The City of Woodcreek has received an application from Edward N. Jones, Jr. & B. Gayle Jones, 17 Brookside Drive, Woodcreek, TX 78676 for a variance to § 156.102 of the Woodcreek Code of Ordinances to allow for the repair/replacement of the illegal non-conforming use of a second story deck and stairs currently in existence across existing property lines and utility easements.

17 Brookside Drive
Second Application
Deck and Stair Replacement
Follow-up Correspondence
ATS Plan Review

PLAN REVIEW

17 Brookside Drive	Edward N.	Edward N. & B. Gayle Jones				
Address	Permit Applicar	Date:				
Subdivision:	Section:	Phase	Block:	Lot:		
Deck Repair & New Stairs		R3	V-B			
Project:	Zonina:	Group	Construction Type:

Site Pan with Setbacks: See Exhibit 1 diagram of property

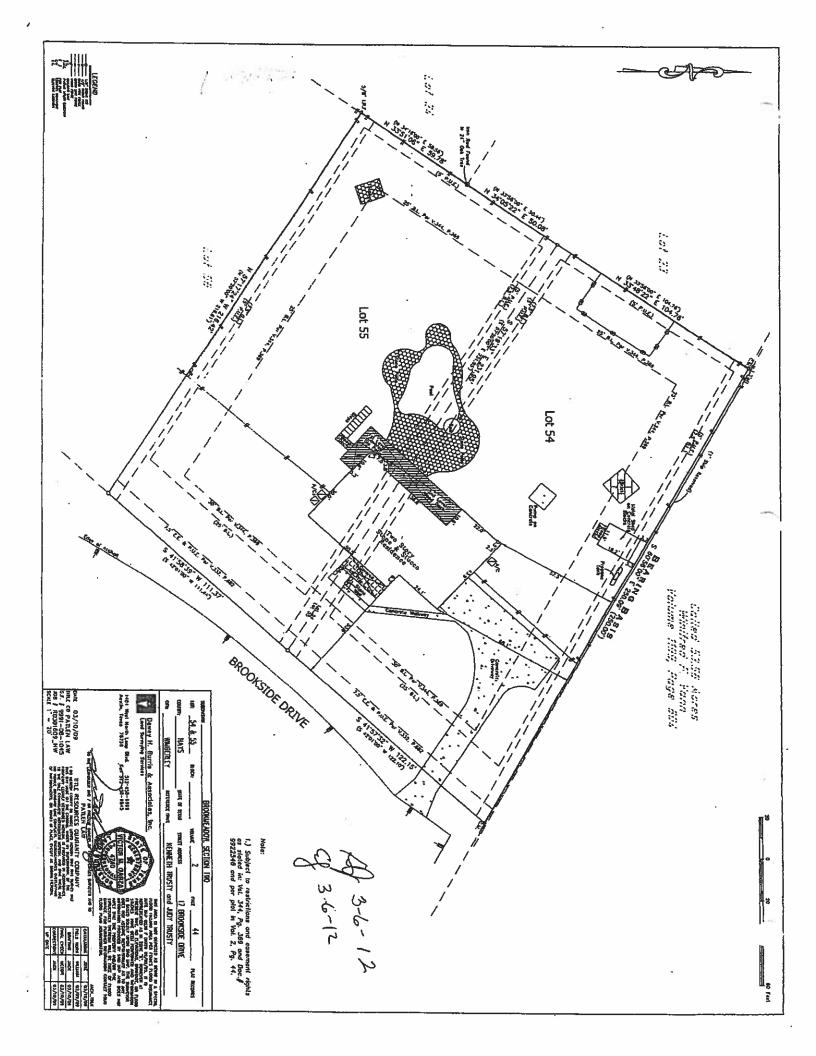
1. Please provide an approved variance from the City allowing for the illegal non-conforming use to continue as shown on the submitted site plan. The deck to be repaired is currently in existence across existing property lines and Utility easements.

The deck to be repaired is currently in existence across existing property lines and Utility easements.
Please provide an approved variance from the City allowing for the illegal non-conforming use to
continue as shown on the submitted site plan.

DECK Restoration

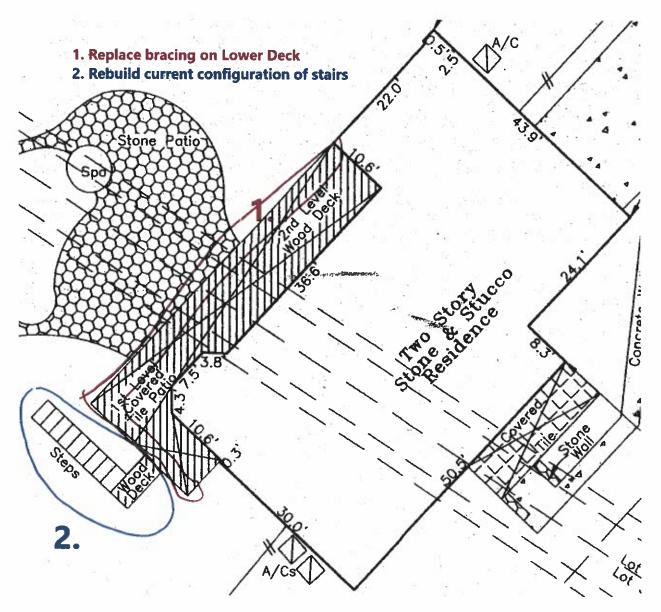
There's a note on Exhibit 3 that says that the stairs will be reconfigured. We'll need elevations, specifications, etc. on that part of the project also.

- 1. Replacing deck posts only, no other changes...
- 2. Replacing stairs as currently configured... Does that answer your questions..?
